INDEPENDENT ADVISORY
PANEL FOR UNDERGROUND
MINING

**NARRABRI COAL OPERATIONS
LONGWALLS 203 - 206
EXTRACTION PLAN**

March 2023

Figure 1: Plans showing the location of Aboriginal Heritage Site Mayfield GG1 (AHIMS 19-6-0192) within the area covered by the LW203-LW206 EP Application (adapted from Figure 1 and Figure 2c of DGS (2022)).

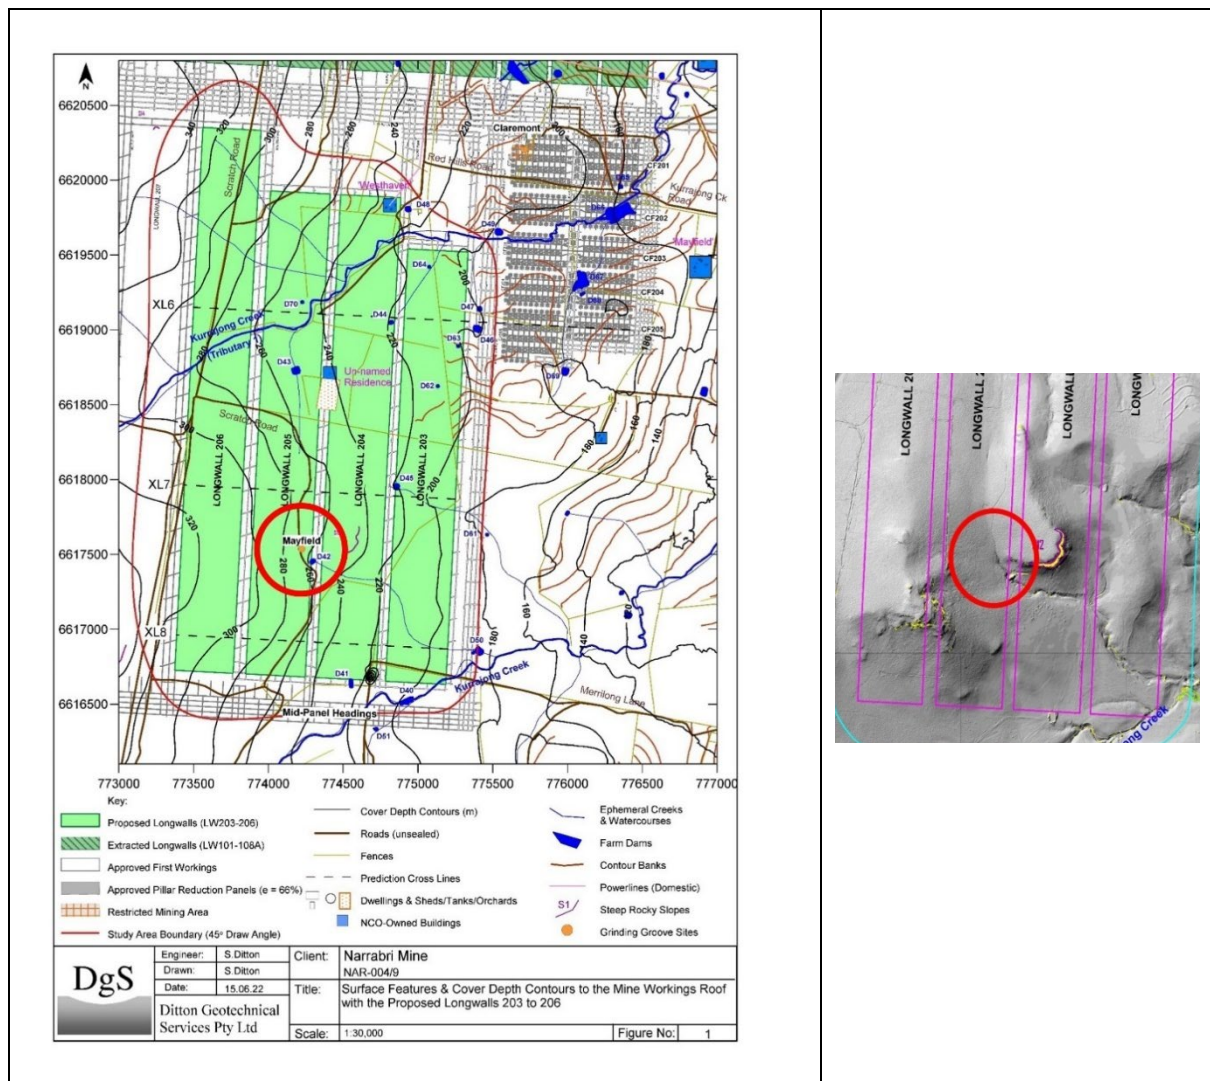
The strain values predicted by DGS (2022) are based on the assumption that the strains are associated with conventional subsidence behaviour and are uniformly distributed over the surface. In the case of rock, this is rarely the case once a fracture is induced in the rock mass. Both field and laboratory testing confirm that a tensile strain of around 0.5 mm/m is sufficient to induce cracking of a rock mass, whereafter cracking tends to concentrate at that site. This means, for example, that a tensile strain of, say, 5 mm/m can be expressed in the field as a 50 mm wide crack every 10 m. Similarly, rock can typically only sustain a uniformly distributed compressive strain up to 3 mm/m before failing and concentrating compressive strain at that site. Therefore, the Panel concurs with DGS (2022) that it is ‘possible’ to ‘likely’ that the axe grinding grooves could be impacted by cracking in their current location (relative to the layout of the longwall panels). However, the Panel notes that it is rarely feasible to predict the locations of concentrated cracks.

Table 3-3 of DGS (2022) provides indicative probabilities of the occurrence of cracking for various ranges of uniformly predicted tensile and compressive strain. These quantify the descriptions of ‘possible’ and ‘likely’ as adopted by DGS. The term ‘possible’ corresponds to a 10 to 50% probability of crack damage and the term ‘likely’ to a >50% probability of crack damage to Mayfield GG1.

The Panel inspected Mayfield GG1 on 9 February 2023. It formed the view that the grinding grooves are located on a ledge of outcropping sandstone in a drainage line. This is not inconsistent with the areal view of the region shown in Figure 1. The nature of the topography in the area raises the question of whether the site could also be impacted by non-conventional subsidence behaviour, specifically valley closure. DGS (2022) makes a general conclusion that *'as the valleys across the longwalls are very broad between crests, the development of 'upsidence' and closure along the creek beds is likely to be negligible'*.⁸ That conclusion has regard to survey measurements across Pine Creek which detected a maximum compressive strain of 6.2 mm/m and uplift of 64 mm. In many circumstances, values of this magnitude can result in negligible impacts on surface structures but a compressive strain of 6.2 mm/m is significant if cracking of the Aboriginal heritage site is to be avoided, especially if this strain is to be added to that component of surface strain resulting from conventional subsidence behaviour.

Figure 5: Make up of gas sources tonnes CO₂e LW203-LW206 based on data in Palaris (2023)

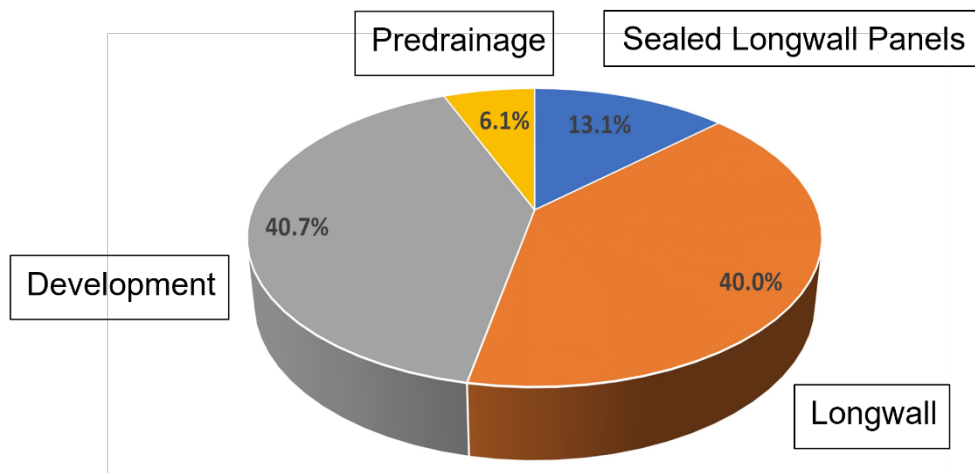
For LW203-LW206, Palaris (2023) attributes a much higher percentage (~81%) of the total emissions to the ventilation stream than has been the case historically. This corresponds to the summation of the development and longwall sources shown in Figure 5. The ventilation stream figure in the 2017 Greenhouse Gas Management plan is 32%. Figure 5 shows only 6.1% of the total gas emissions are expected to be derived from predrainage. This compares with a figure of 33% given in the 2017 Greenhouse Gas Management plan. The apparently lower requirement for predrainage is primarily because the gas content is assessed to be below the threshold required to initiate outbursts in the working face.

Figure 6: Ratio CH_4/CH_4+CO_2 for LW203-LW206 derived from Palaris (2023)

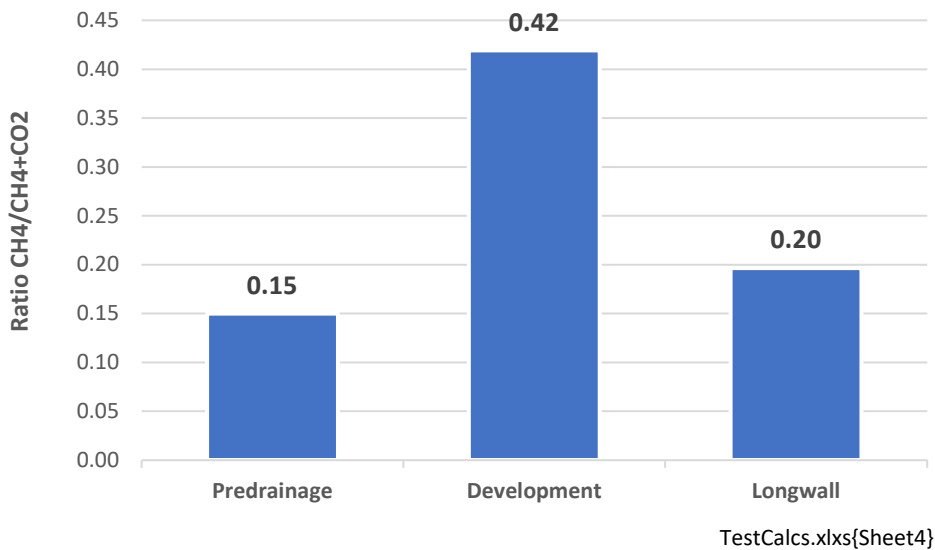
Figure 6 shows the CH₄/CH₄+CO₂ ratio for different mining stages. The figure of 0.42 for development mining appears quite high given that the predicted in-situ gas ratio is around 0.2 but could be plausible, depending on modelling assumptions. The values are produced with the SIMEDWin gas reservoir simulator using a coal permeability of 10 mD.

For the modelling, a significant source of gas (~35%)²³ has been assigned to the non-coal formations (Digby Conglomerate RDC, Arkaroola Formation ARK) as apparently model results based only on gas in the coal are insufficient to explain the GHGE to date. Further, the modelling appears to assume the same CH₄ concentration in the non-coal strata as in the coal.

The validity of the assumed non-coal gas quantity and composition should be reassessed. The Panel considers it more likely that only CO_2 is present in the non-coal formations. If this consideration is correct it may explain why the CH_4/CH_4+CO_2 ratio for the ventilation exhaust gas is historically lower (0.04) than for the predrainage gas (0.06) in the 2017 Greenhouse Gas Minimisation Plan (WHC, 2017). Typically, predrainage gas would be confined to the Hoskissons seam (containing CH_4) while ventilation gas would be released from all sources. Moreover, it would indicate that the total CH_4 estimated in the Palaris review could be an over-estimate and this, in turn, would affect the GHG forecasts and proposed mitigation strategies.

Figure 7: Gas make curves for CO₂ and CH₄, LW109, Narrabri Mine (derived from data supplied by NCOPL file GHG 2a – Longwall 108 and 109 Gas Make Data 17Jan23.xlsx)

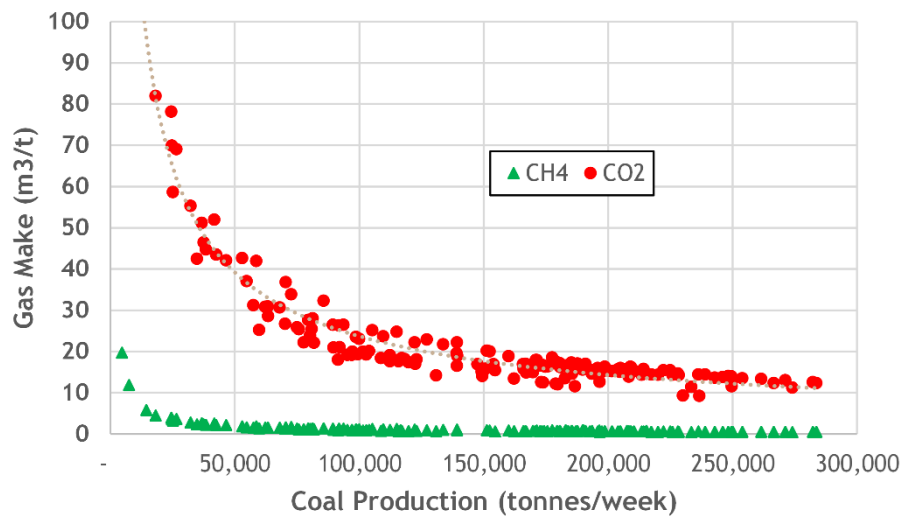
One other potential avenue for minimisation of GHGE from coal production that has not been considered by NCOPL is to exploit the relationship between production of seam gas in the strata versus rate of longwall face retreat. There is a zone of active gas emission extending from the longwall face to the rear abutment in the goaf (see Figure 2) but behind the rear abutment the emissions are much reduced. The faster the face retreats, the quicker gas emissions become constrained to the reduced values behind the rear abutment. A fast rate of mining produces more gas per unit of time, but less gas per tonne of coal mined due to this process, as shown by CO₂ gas makes in Figure 7 for LW109 at Narrabri Mine.
